**Structural RAIs****RAI 3-1:**

Provide the structural evaluation and/or analysis for the Type 5 basket in Appendix 3.9.2, "EOS-37PTH AND EOS-89BTH BASKET STRUCTURAL ANALYSIS."

**Figure RAI 8-6-1**  
**Reduction factors for modulus of elasticity at elevated temperatures**

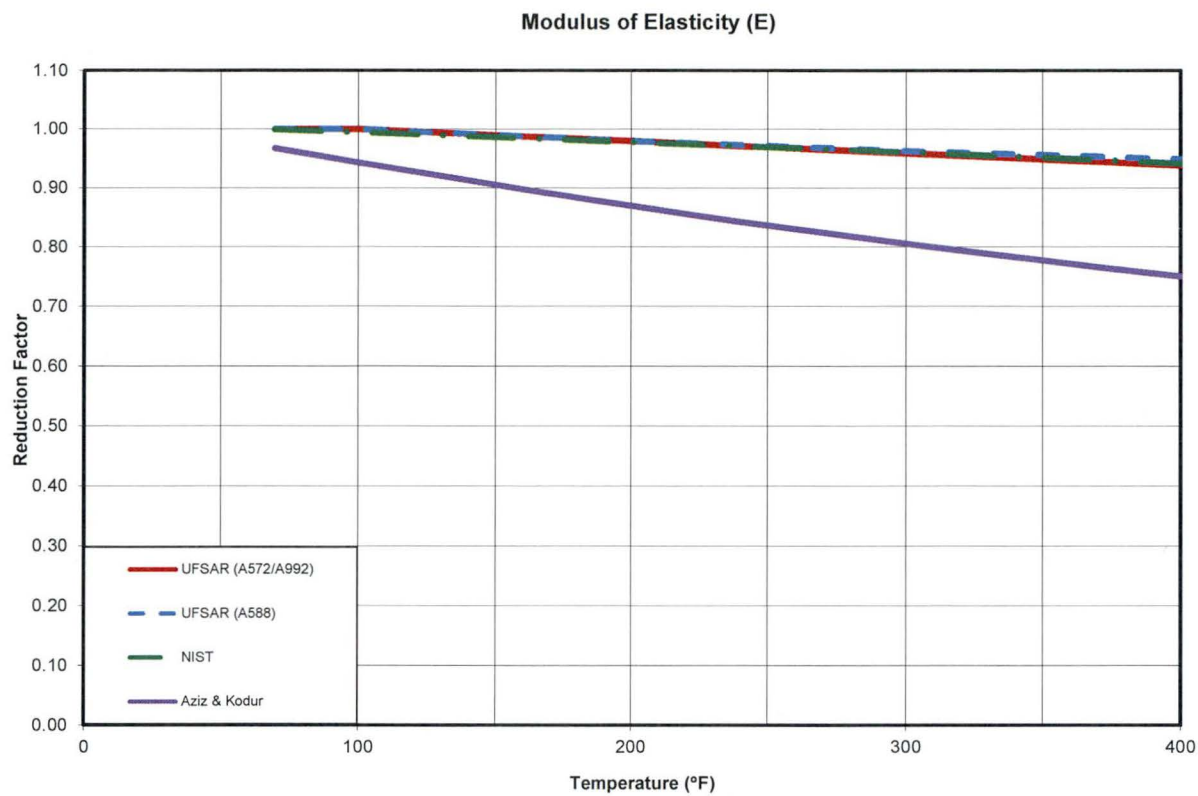
Provide the following additional information for UFSAR Tables A.8-2, A.8-3 and A.8-4 which apply to ASTM A572 Grade 50, ASTM A992 Grade 50, and ASTM A588 steels respectively:

2. Provide allowable stress values for these materials as a function of temperature, a technical basis for the determination of the allowable stresses and an analysis showing that the actual stresses do not exceed the allowable stresses.

Figures RAI 8-6-1, RAI 8-6-2, and RAI 8-6-3 show the temperature-dependent reduction factors (for temperatures up to 400 °F) of the following four materials for the elastic modulus ( $E$ ), yield strength ( $F_y$ ), and tensile strength ( $F_u$ ), respectively:

Figure RAI 8-6-1 shows that the temperature-dependent values of modulus of elasticity used in the UFSAR for A572/A992 and A588 steels are in very good agreement with those from NIST Technical Note 1907 [2], but greater than those from Aziz and Kodur [3] throughout the entire temperature range. Figure RAI 8-6-2 shows that the temperature-dependent values of yield strength used in the UFSAR for A572/A992 and A588 steels are slightly less than those from NIST [2] and Aziz and Kodur [3] for the entire temperature range, with the exception that the UFSAR properties for A588 are slightly greater than those from NIST [2] for a low temperature range (< 120 °F). Figure RAI 8-6-3 shows that the temperature-dependent values of tensile strength used in the UFSAR for A572/A992 and A588 steels are in good agreement with those from NIST [2] and Aziz and Kodur [3] for the entire temperature range.
